City of Portland, Maine – Building or Use Permit Application 389 Congress Street, 04101, Tel: (207) 874-8703, FAX: 874-8716

REASON FOR PERMIT: reconstruct front porch - not to exceed existing footprint

BUILDING PERMIT REPORT

DATE: 7/24/97 ADDRESS: 34 Brentwood St.
REASON FOR PERMIT: Reconstruct Front Porch
BUILDING OWNER: Fournier
CONTRACTOR: Mike Walker
PERMIT APPLICANT: Mike Walker APPROVAL: *1 *2 *10 *13 *14 *27 *28 DENIED

JOB LOCATION:
 34 BRENTWOOD ST
 NANCY FORNIER (OWNER)

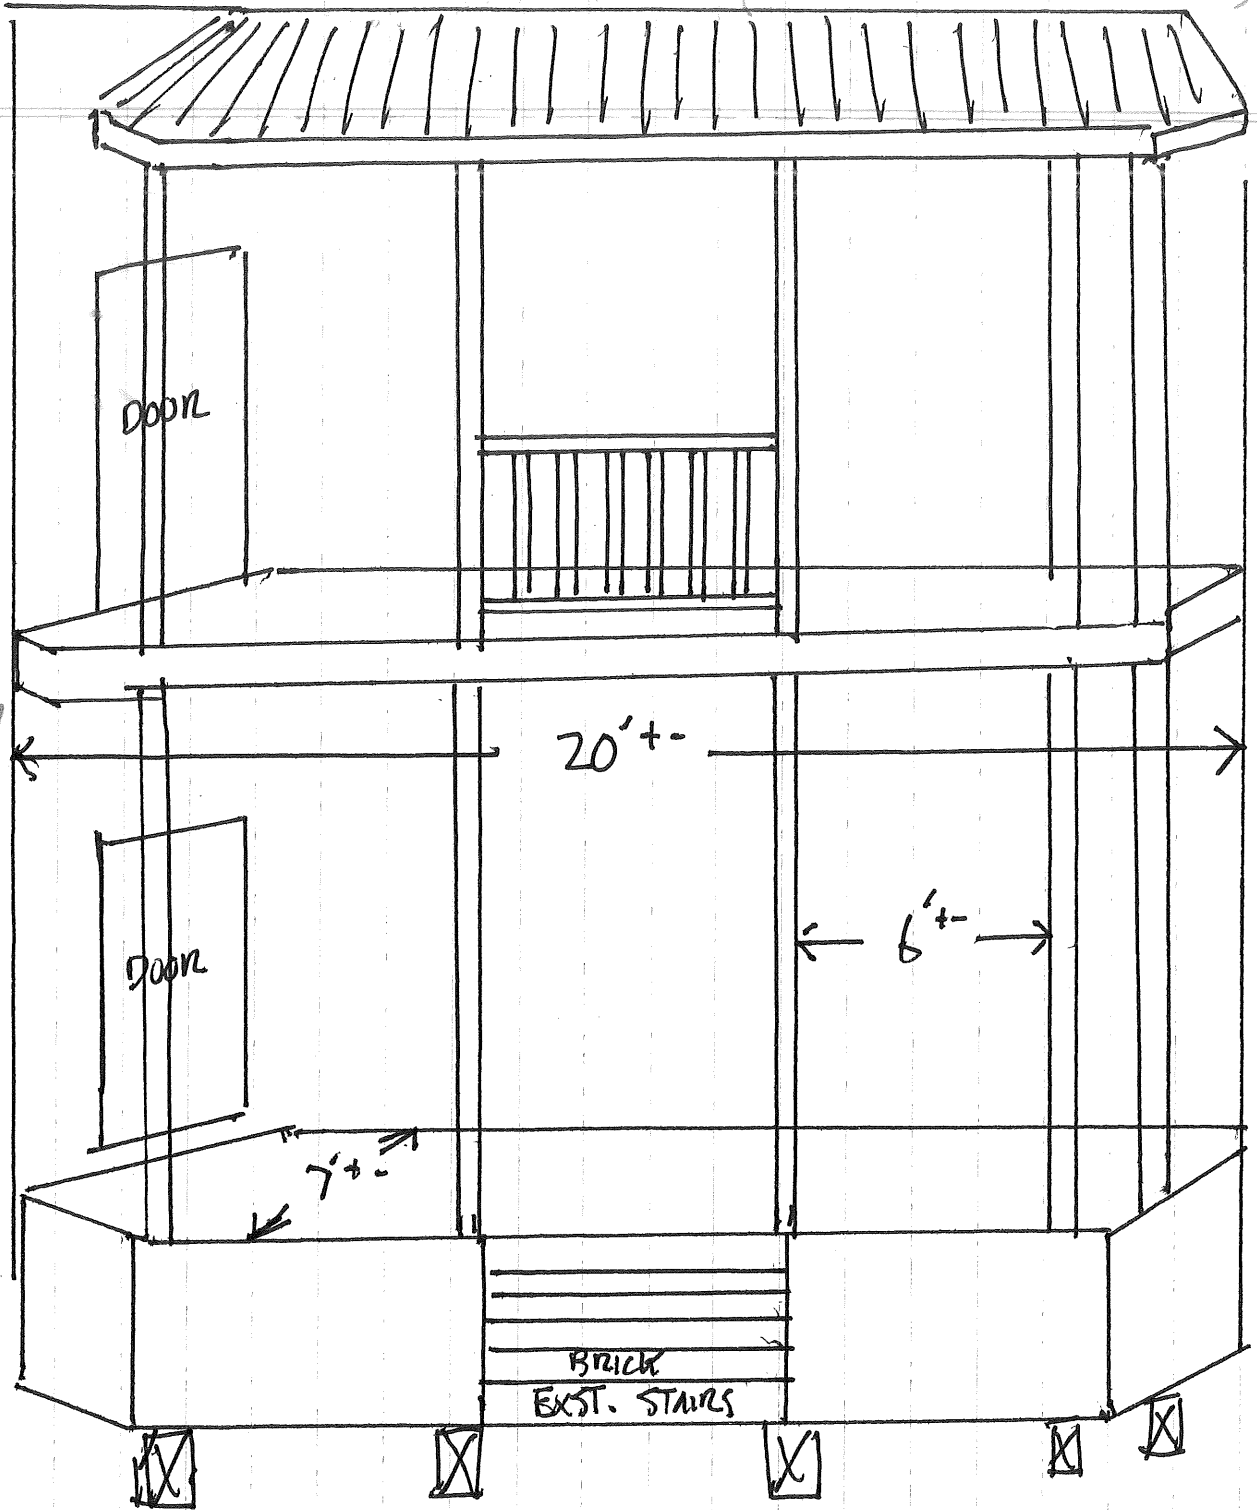
7. Sound transmission control in residential building shall be done in accordance with Chapter 12 section 1214.0 of the city's building code.
 - *8. Guardrail & Handrails A guardrail system is a system of building components located near the open sides of elevated walking surfaces for the purpose of minimizing the possibility of an accidental fall from the walking surface to the lower level. Minimum height all Use Groups 42" , except Use Group R which is 36". In occupancies in Use Group A, B, H-4, I-1, I-2 M and R and public garages and open parking structures, open guards shall have balusters or be of solid material such that a sphere with a diameter of 4" cannot pass through any opening. Guards shall not have an ornamental pattern that would provide a ladder effect.

9. Headroom in habitable space is a minimum of 7'6".
 - *10. Stair construction in Use Group R-3 & R-4 is a minimum of 10" tread and 7 3/4" maximum rise. All other Use group minimum 11" tread. 7" maximum rise.

26. All electrical and plumbing permits must be obtained by a Master Licensed holders of their trade.
- ✓27. The Sona Tubes MUST rest on footing with anchor connecting The two,
